ADDENDUM TO COUNCIL ASSESSMENT REPORT OF 2 NOVEMBER 2022

HUNTER AND CENTRAL COAST REGIONAL PLANNING PANEL

PANEL REFERENCE & DA NUMBER	PPSHCC-122 & 16-2022-97-1
PROPOSAL	Alterations and additions to existing educational establishment (St Michael's School, Nelson Bay) including refurbishment of grounds and buildings, removal of existing demountable buildings, new centre based child care including out-of-school hours care, new admin building, new car park, subdivision, landscaping, fencing and associated civil works.
ADDRESS	LOT: 2 DP: 216064 12 Sproule Street NELSON BAY
APPLICANT	CKDS Architecture Pty Limited
OWNER	Trustees of the Roman Catholic Church
DA LODGEMENT DATE	23 February 2022
APPLICATION TYPE	Regionally Significant Development
REGIONALLY SIGNIFICANT CRITERIA	Clause 5, Schedule 6 of <i>State Environmental Planning Policy (Planning Systems) 2021</i> : Private Infrastructure and Community Facilities – Educational establishments and childcare centres
CIV	\$8,152,406
CLAUSE 4.6 REQUESTS	Nil
KEY SEPP/LEP	<i>State Environmental Planning Policy (Biodiversity and Conservation) 2021</i> <i>State Environmental Planning Policy (Planning Systems) 2021</i> <i>State Environmental Plann

Figure 1: Wahgunya Rd Traffic Plan

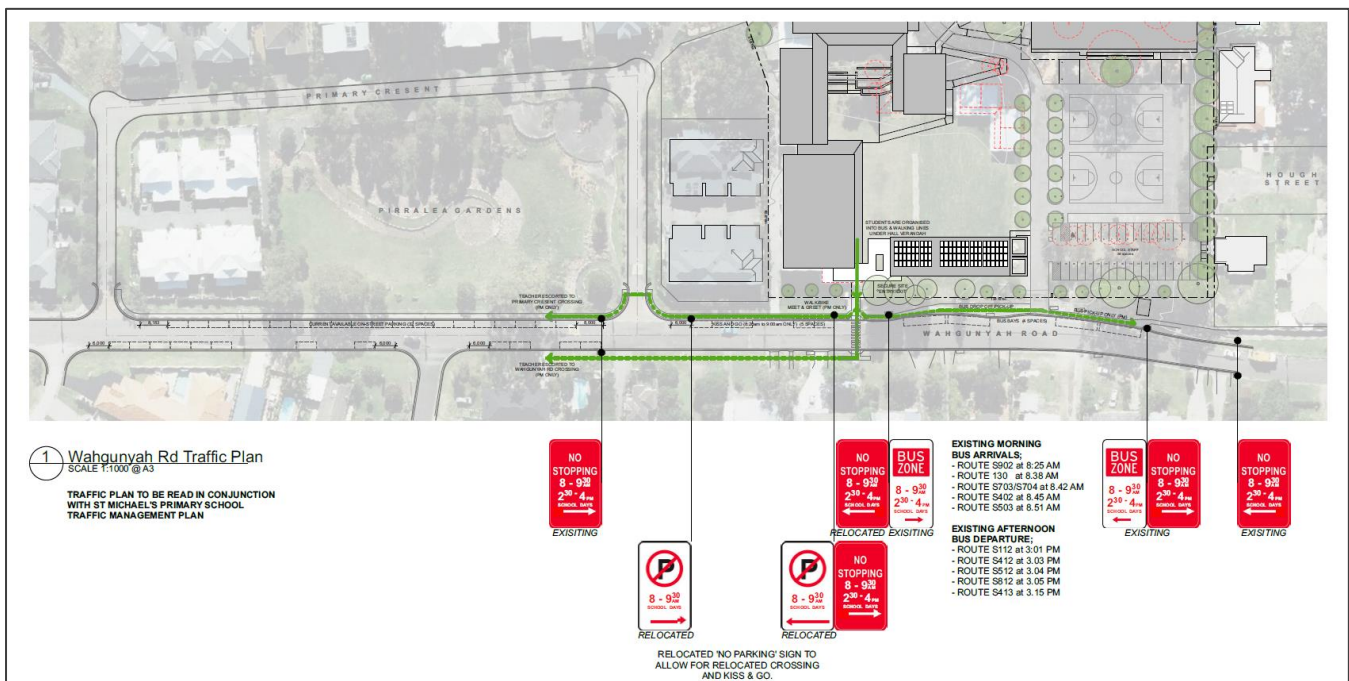
The amendments to the TMP indicate that currently a peak of 4 buses would arrive at the site at the same time during the afternoon pick-up. The amended TMP and Figure 1 above illustrates the areas of the road shoulder currently used to facilitate the bus pick-up. The 4 bus spaces extend over the Wahgunyah Road Carriageway, which would result in some queuing of vehicles whilst the buses are

loading. The amended proposal does not propose any works within the road verge to rectify this historic deficiency.

Figure 1: Proposed stormwater works within Wahgunyah Road Reserve

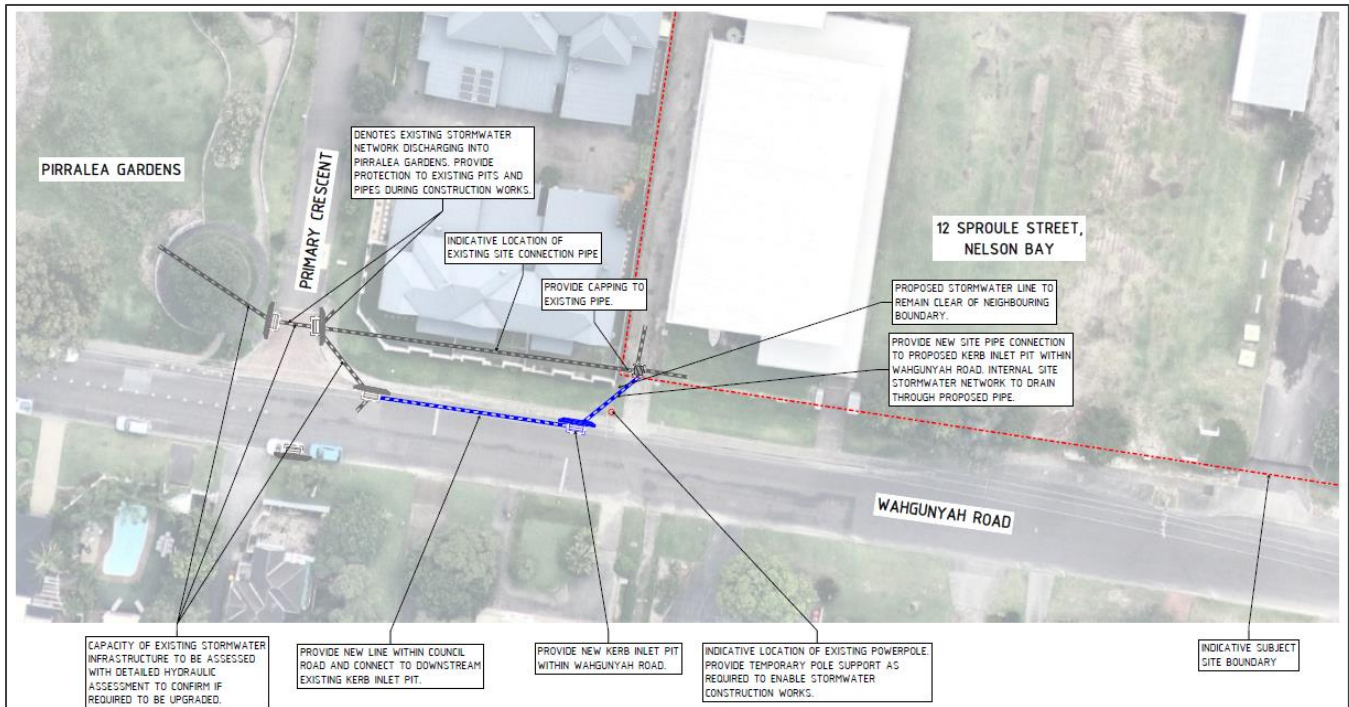
An External Site Connection Sketch has been provided by Northrop Engineering to detail the required works within the Wahgunyah Road reserve if an easement cannot be established over the existing stormwater line currently running through Lots 1-3 DP1098930. The Wahgunyah Road works are shown in **Figure 2** below.

The proposed stormwater works within the Wahgunyah Road Reserve would not result in any adverse environmental impacts, noting that the road reserve is cleared of any significant vegetation.

Figure 3: Wahgunyah Rd Traffic Plan

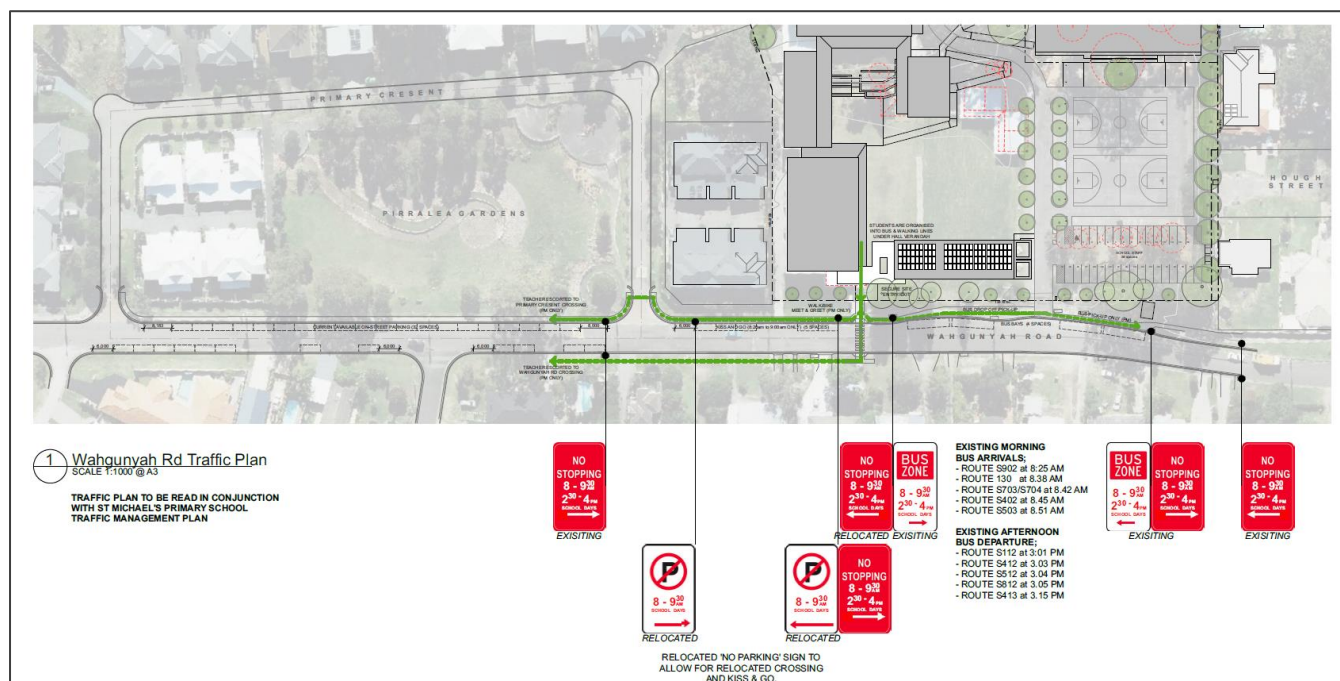
The amended TMP indicates that currently a peak of 4 buses would arrive at the site at the same time during the afternoon pick-up. The amended TMP and Figure 3 above illustrates the areas of the road shoulder currently utilised to facilitate bus pick-ups. The 4 bus spaces extend over the Wahgunyah Road carriageway, which would result in some queuing of vehicles whilst the buses are loading and unloading. The amended proposal does not propose any works within the road verge to rectify this historic deficiency.

Despite the historic deficiency, the applicant notes the proposed development does not involve an intensification of the school facility, noting that there are no additional classrooms proposed and there would be a net loss of classroom gross floor area. Moreover, the maximum number of students is not proposed to increase as a result of the proposal. For this reason, the nexus for the imposition of extensive road widening works and relocation of public assets required to widen the bus parking are not considered required under this proposal. Should a future DA be submitted which increases the floor area of classrooms or maximum student numbers, the demand for the bus services would increase and therefore warrant a full reconsideration of the traffic plan and bus queuing area.

Notwithstanding the above, should the Panel be minded to rectify this historic deficiency as part of this development, a condition requiring upgrades to the Wahgunyah Road carriageway to improve bus queuing has been provided as part of the recommended conditions (condition 2.0(10b)).
